Interactive comment on “Reassessing flood frequency For the Sussex Ouse, Lewes: the Inclusion of historical Flood Information since AD 1650” by N. Macdonald et al.

NHESS manuscript nhess-2013-363, Reassessing flood frequency For the Sussex Ouse, Lewes: the Inclusion of historical Flood Information since AD 1650 by N. Macdonald, T.R. Kjeldsen, I. Prosdocimi and H. Sangster

Point to point authors' reply to the Referees' reports. Please find below responses addressing the reviewers comments, specific points have been directly addressed in the revised paper attached and are not detailed here. We would like to thank the three reviewers for their detailed comments on the paper, which have improved it considerably.

Fig. 1.

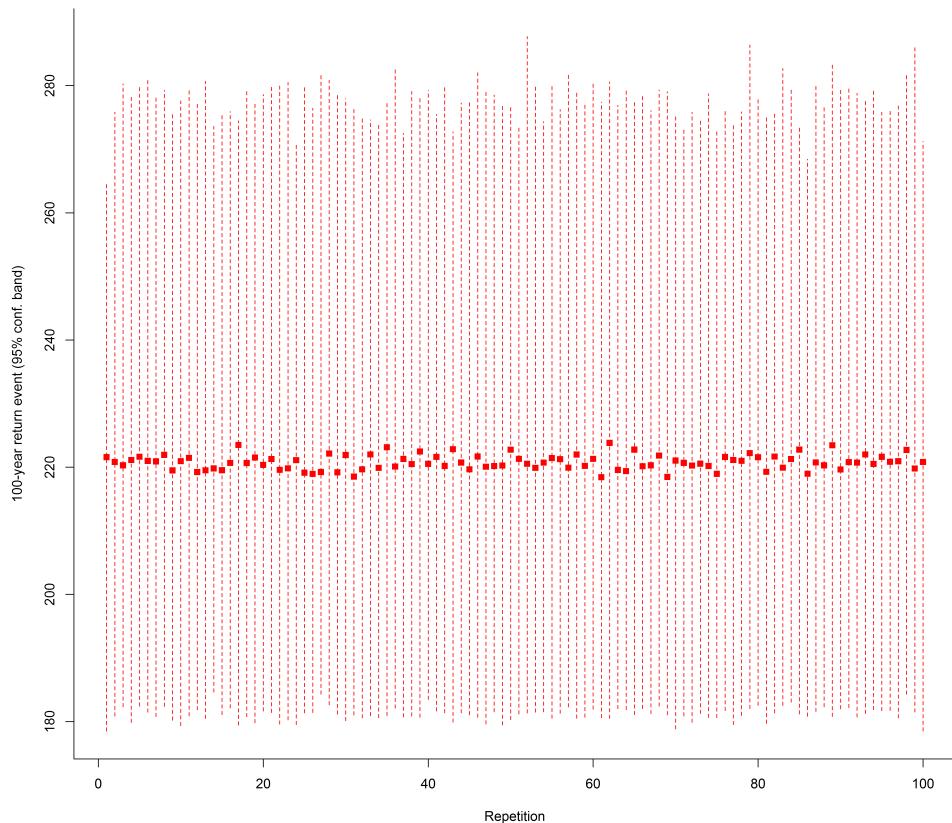
The inference methods used are standard (MLE) are not up to date (evaluation of the confidence intervals based on linear approximations of the likelihood function and on the assumption of a Gaussian distribution). More rigorous inference approaches based on Bayesian MCMC methods that are now frequently used in hydrology (refs) would have been a better suited choice and helped to go further into the analysis. The choice of using the standard maximum likelihood method rather than Bayesian inference was partially taken to keep the presentation of the material in the paper simple. The results

and their interpretation would only change marginally if a Bayesian inference was used rather than standard maximum likelihood. We have added the following comment in Section 4 (at what was page 7628): "Rather than the standard numerical optimization a Bayesian MCMC approach as the one presented in Gaume et. al. (2010) could be employed to maximise the equations in (5) or (6). These methods are readily available in the nsRFA library in R (Viglione, 2013). The advantage of using a Bayesian approach is that a full posterior distribution for the parameter estimates and any relevant quantity can be obtained, and no approximations like the ones in (9) are needed. The authors experience though is that little difference can be found in the final estimates, and that the BayesMCMC function can, in some cases, give computational issues or can be fairly slow to reach convergence. The interpretation of the results discussed in Section 5 would not change if Bayesian estimates would be used" Indeed, we have fitted the model for the historical data with the Bayesian framework available in the nsRFA:BayesMCMC function in R and the 100 year return level estimates with a 95% confidence/credibility bands for increasing perception thresholds are shown in the picture below. Almost no difference can be seen for the point estimate, and the maximum likelihood estimator consistently has a lower upper bound, mostly due to the asymmetry of the Bayesian credibility intervals. We also found that the outputs for the Bayesian inference procedure do not always give a very good convergence and can be quite different from one run to the other. In Figure R.1 100 replication of the estimated 100-year return event with 95% confidence bands for the case in which only the highest 2 historical event are kept in the model is shown. Each replication was started at similar starting points (corresponding to the L-moment estimates obtained from the systemic records plus some small noise) and each replication is based on a 3 chains of 17000 MCMC samples with 2000 observations of burn-in. Although the differences are not really large, some inconsistencies can be seen. Of course these inconsistencies in the Bayesian results might be the result of a computational issue and poor convergence: Figure R.2 show results obtained when using 3 chains of 100000 MCMC samples with 2500 observations of burn in. The results are indeed more con-

sistent but this is obtained at the cost of needing 15 minutes to t the model, instead of the 2 minutes needed for the models shown in Figure R.1.

[Interactive Comment](#)**Fig. 3.**

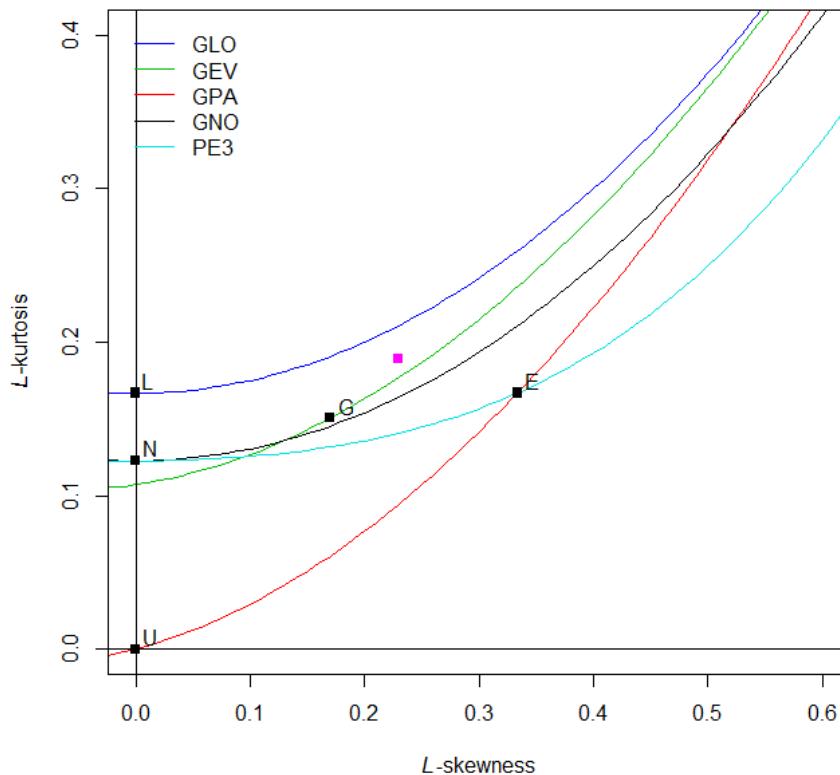
Other discussion issue is the problem of choosing the distribution of annual maxima in the context true - false distribution. Model misspecification results in bias of parameters, consequently translated to the bias of quantiles estimates. Good asymptotic properties of estimation methods vary significantly when the model is untrue, what is the case in FFA, where we do not know the parent distribution of maxima. Authors' statement that "GLO might not be the true distribution" (p. 7627 and 7628) seems to represent excessive cognitive expectations in relation to models and the role they play. However accepting the saying of Rene Thom (I quote from memory) "The truth is not limited by the false, but by the lack of significance", it will be better perhaps to think that the model might be not good enough to describe the parent population with sufficient accuracy.

We agree with the referee's take on this, but we also would like to point out that a choice on the distribution of the annual maxima must be made in order to fit the model. For the gauged only the GLO distribution, which is the recommended distribution to be used for British AMAX data, is not rejected by formal testing and seem to be reasonable when

looking at the Lmoments diagram in Figure R.1. We have rephrased the statement concerning the GLO distribution to: "the GLO distribution might not provide a good description of the true underlying distribution. " We have also added the following at the end of the paragraph which was at the top of page 7628. "The uncertainty related to the assumed distribution cannot be avoided and it is not expected that the effect of a model misspecification would be larger when using historical data combined with gauged data."
